SP2020-002

Lot 10, Blk A, Whitmore Drive

Project Plan Review History

SP2020-002; 855 Whitmore Drive

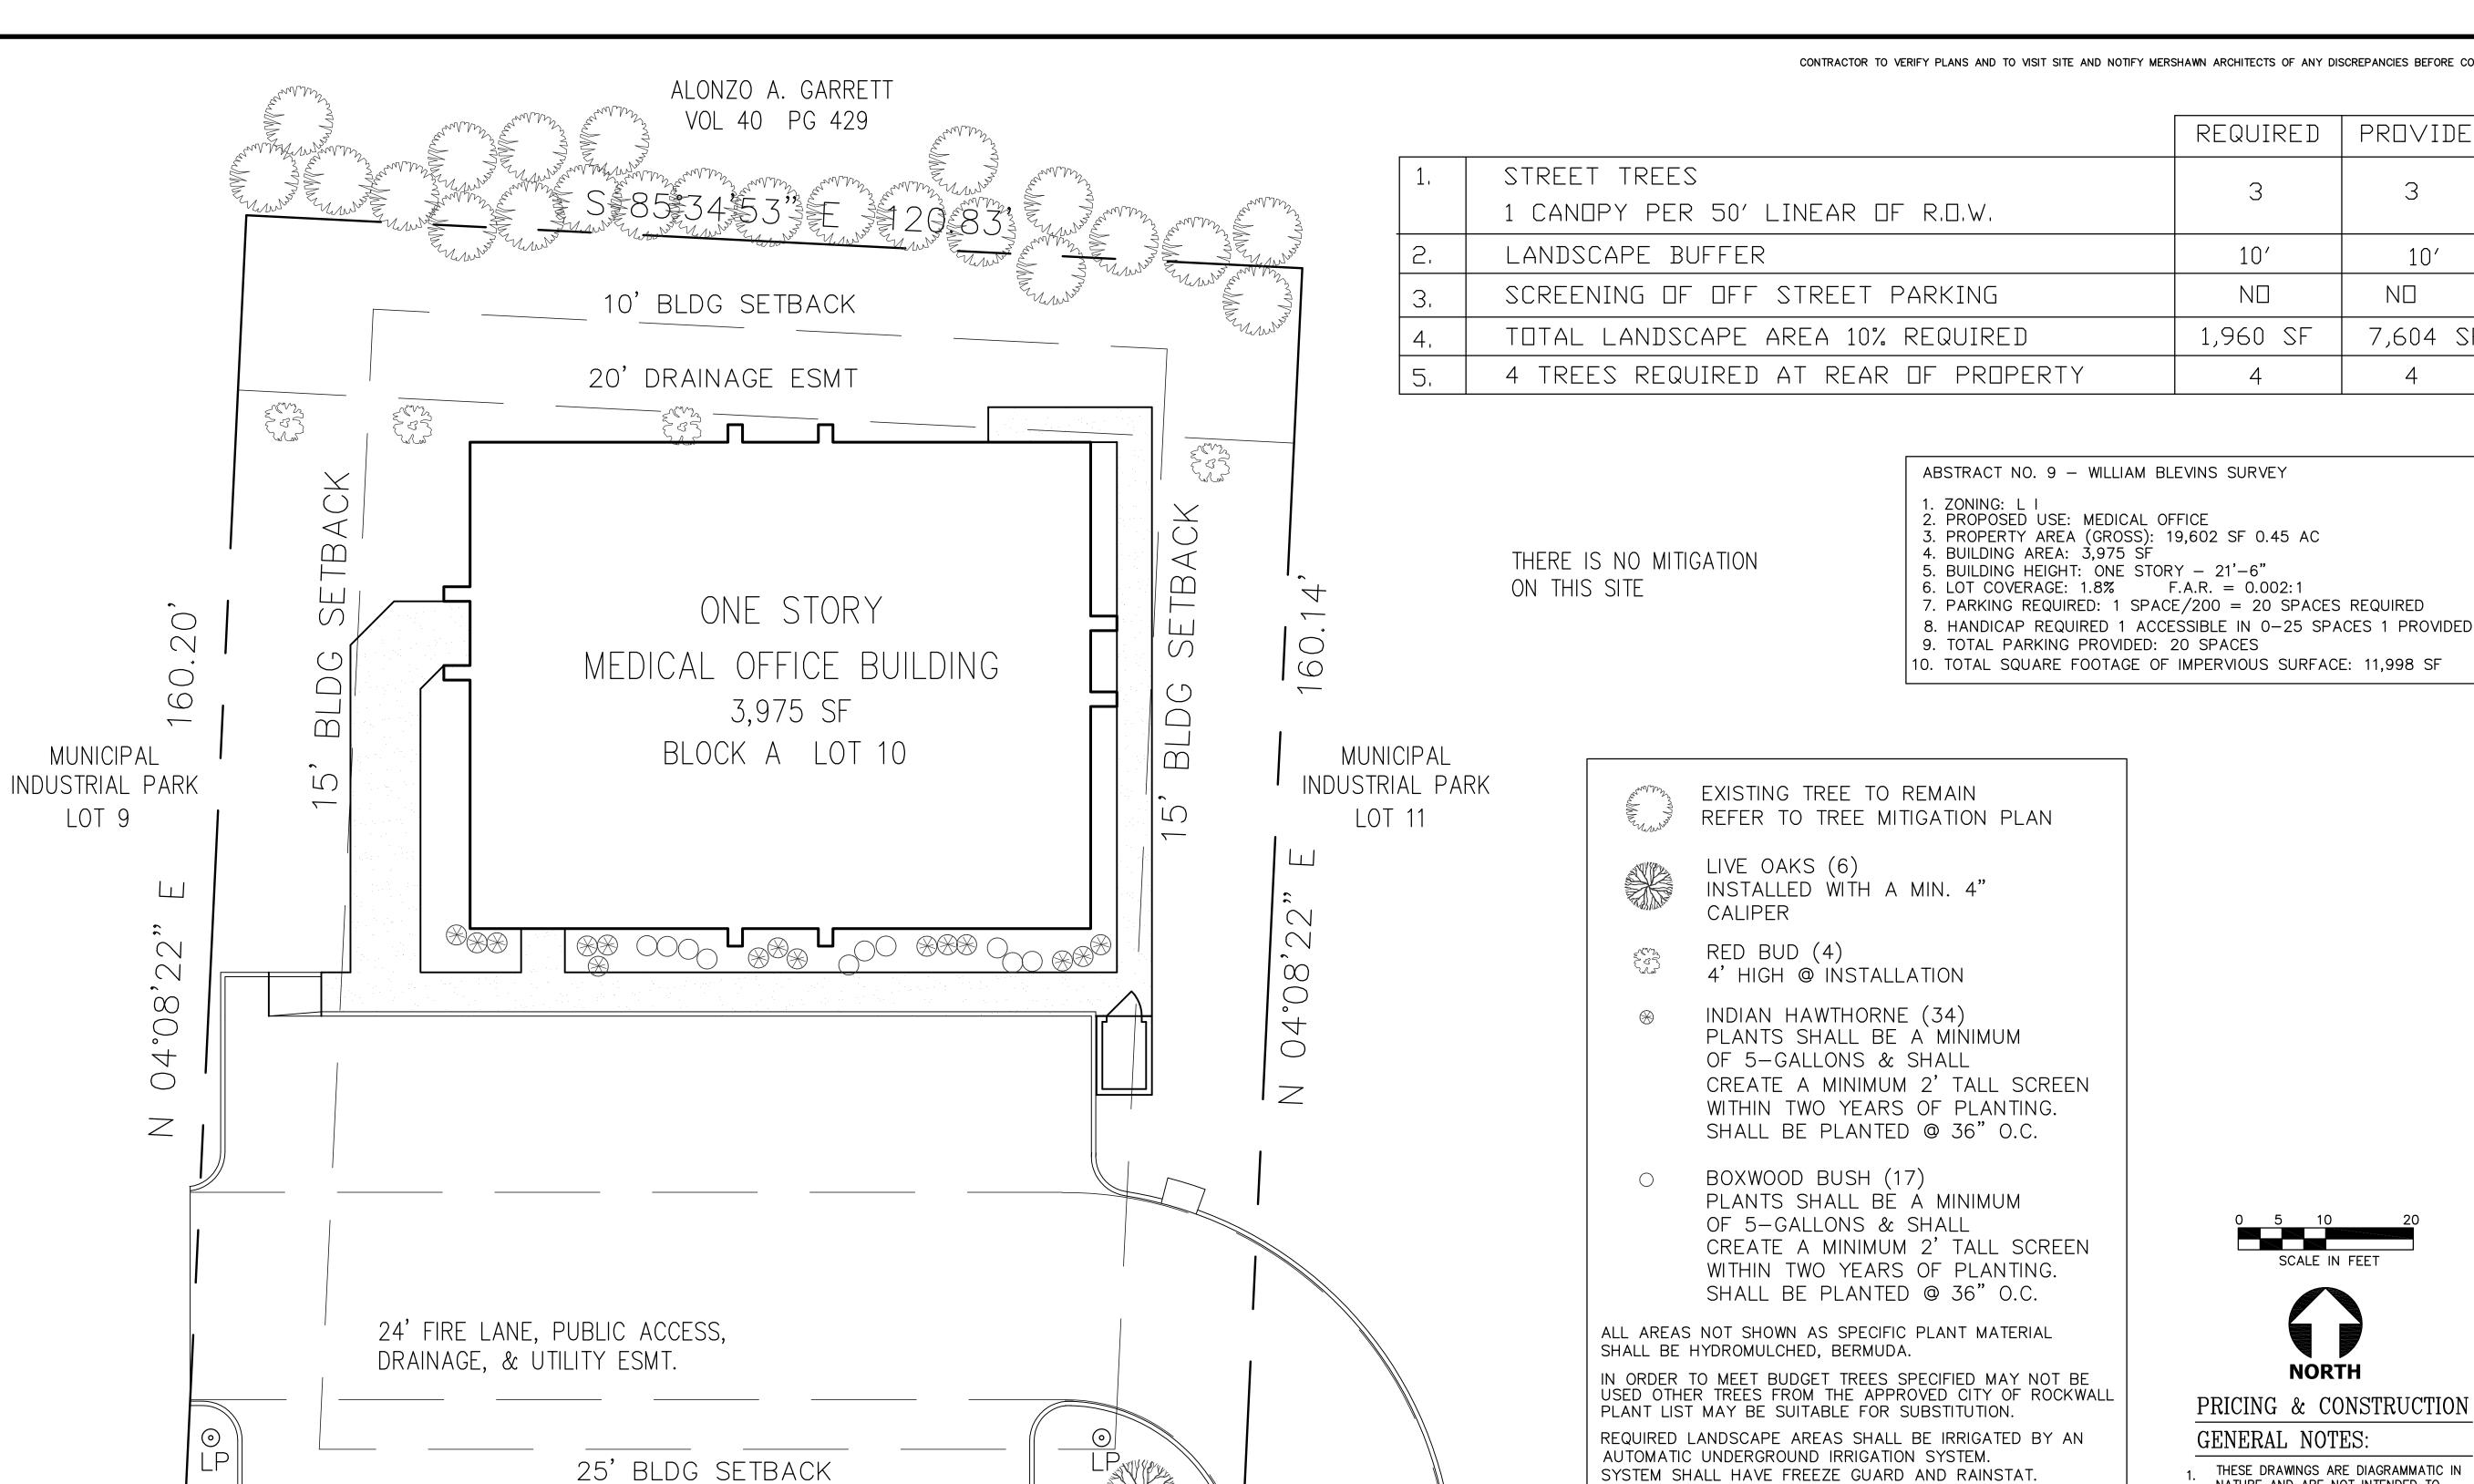
- 1) Please provide turn radii and drive widths.
- 2) Please note, a min. of 10-foot wide landscape buffer is required along the entire length of any nonresidential lot that abuts a public right of way. All buffers shall incorporate ground cover, a built-up berm, and shrubbery along the entire length of frontage. Berms and shrubbery shall have a total min height of 30-inches. A min of one (1) accent tree per 50 linear feet is required.

- 3) Please show parking
- 4) Please dimension a typical parking space.
- 5) Please show centerline of Whitmore Dr.
- 6) Please note, canopy trees are a min. of 4 caliper inches, accent trees are a min. pf 4-feet in height, and shrubs are a min. of 3 gallons.

- 7) Please note, the min landscaping percentage is 15%.
- 8) Please note that no parking space shall be more than 80-feet from a canopy tree
- 9) Please label property line.

- 10) Please provide site data table as requested above for site plan

- 11) Please review Article 8, Landscape and Fence Standards, of the Unified Development Code (UDC)
- 12) Please note, hydromulch is not permitted
- 13) Please show grass as a hatch.
- 14) Please provide radii and drive width.

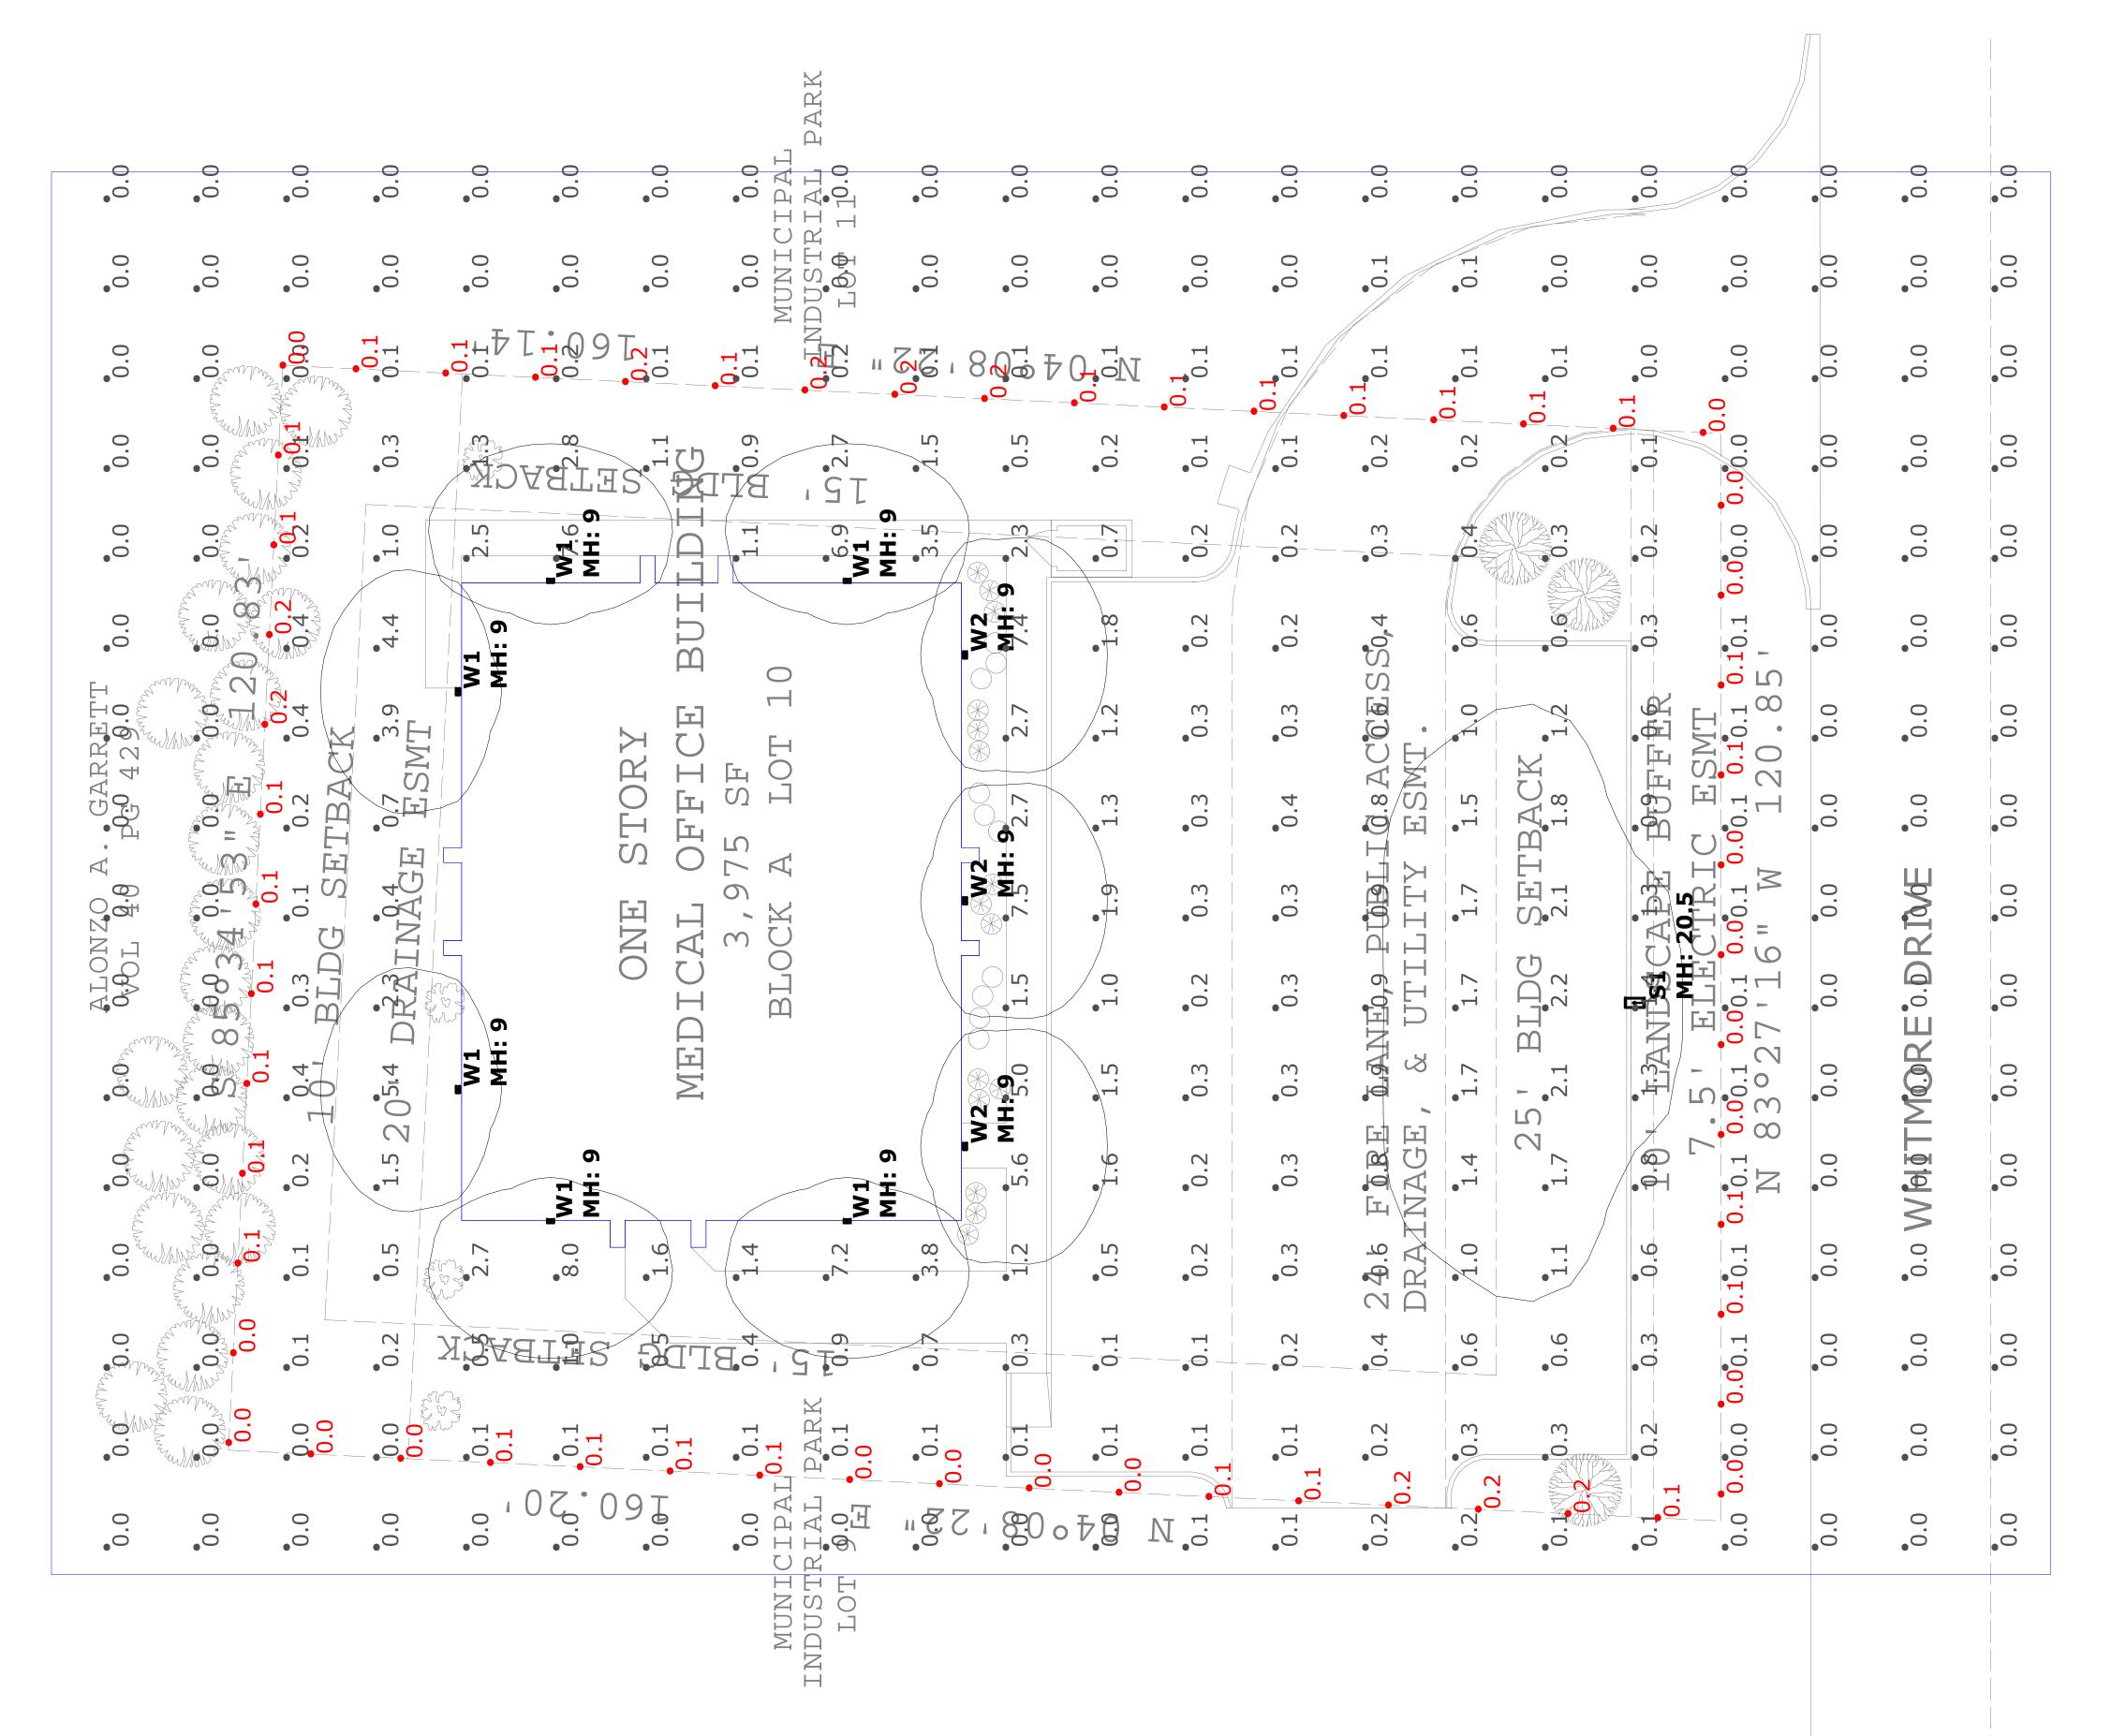
- 1) Please provide site data table
- 2) Please provide vicinity map
- 3) Please provide north arrow.
- 4) Please orient the plan to match the site plan and landscape plan

- 5) Please show and label property line.
- 6) Please clarify plan. There are many overlapping items.
- 7) Please provide graphic and numeric scale.
- 8) Please provide title block in lower left corner
